Permit Number: 091386

has permission to install hood system

AT 25 FOREST AVE CB# 037 A022001 City of Portland

City of Portland, Maine - Building or Use Permit Application

SECTION VIEW - MODEL 3650BD-2

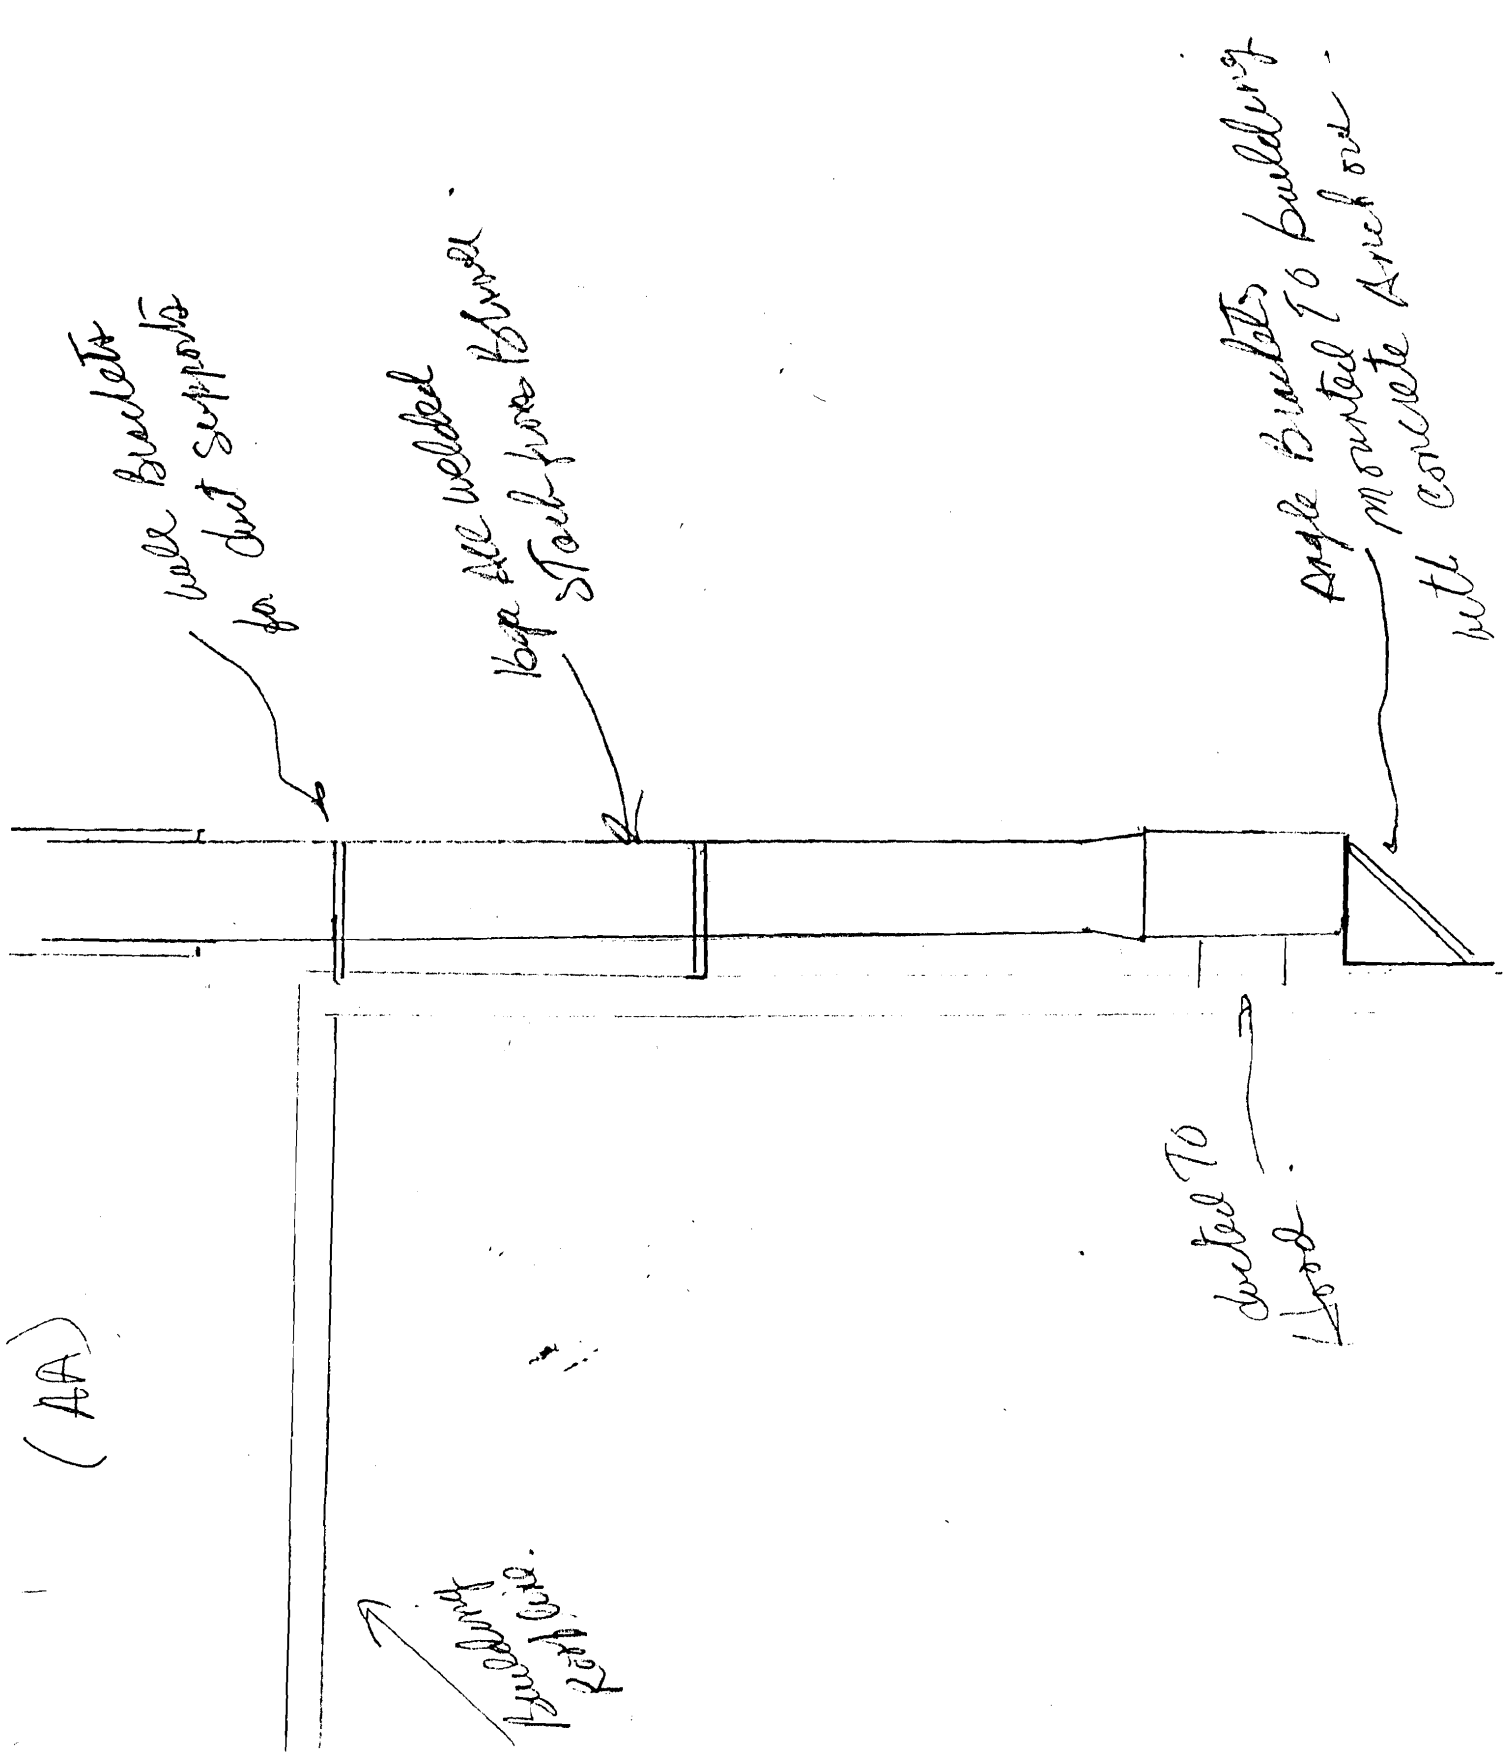
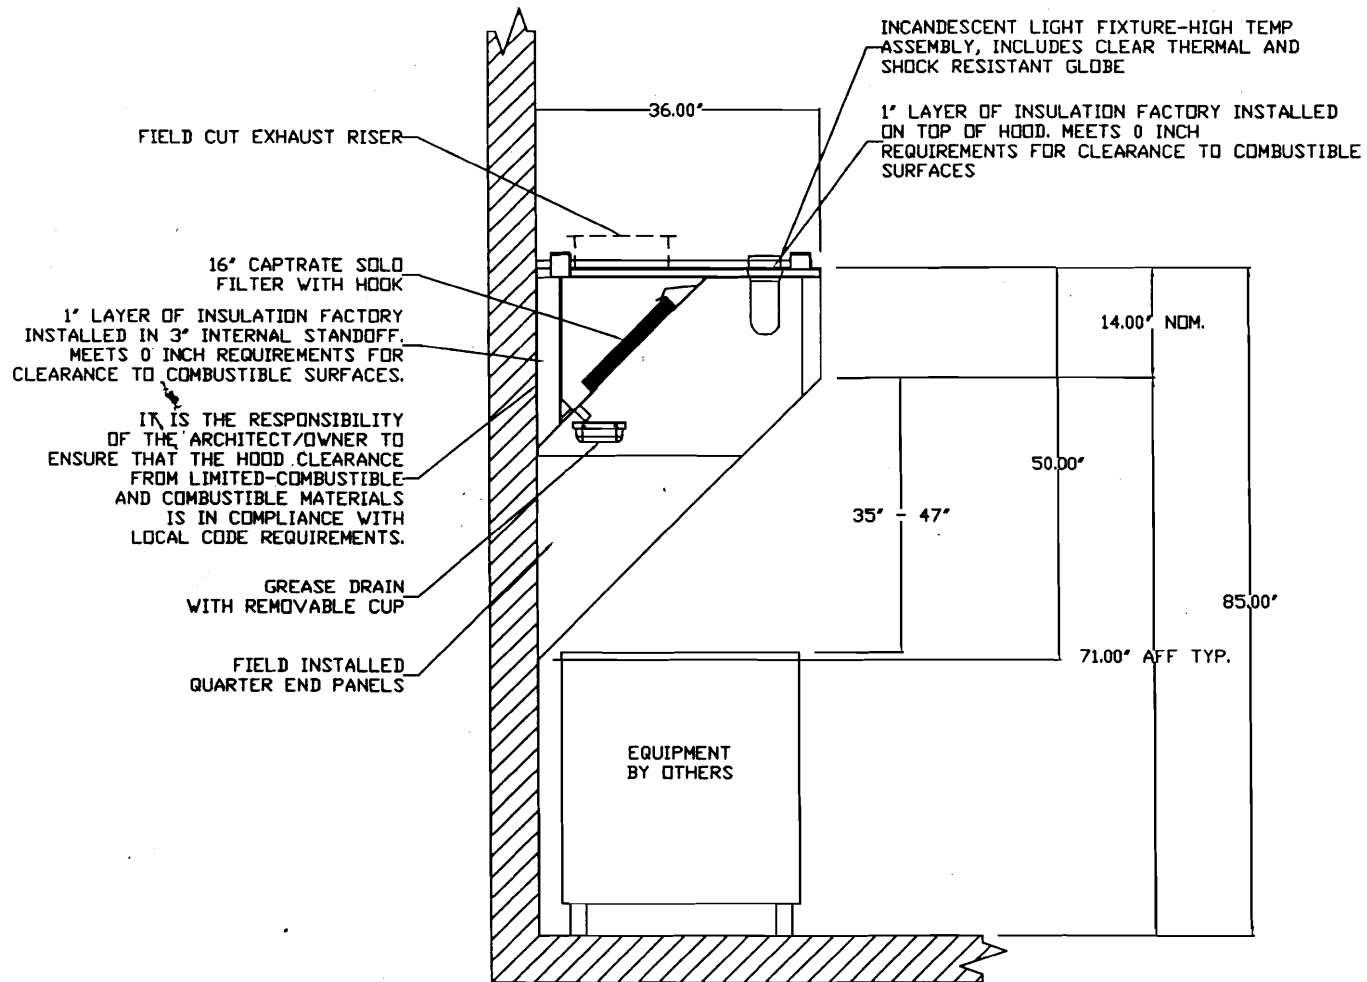
1/19/2010-jmb: Left vcmmsg with Paul R. For floor plan showing where the hood and equipment is, the height above the hood and cleanouts. Paul left vcmmsg about 0 clearance wrap above hood and around duct. Ok to issue

- 1) Approval of City license is subject to health inspections per the Food Code.
- 2) New cafe, restaurant, lounge, bar or retail establishment where food or drink is sold and/or prepared shall meet the requirements of the City and State Food Codes
- 3) Equipment must be installed in compliance per the manufacturer's specifications
- 4) The hood, duct and exhaust shall be installed per IMC 2003 and NFPA 96
This permit is approved based on the plans submitted and updated for reductions in the cleaances based on the application of a UL approved fire wrap or equivalent assembly per code.
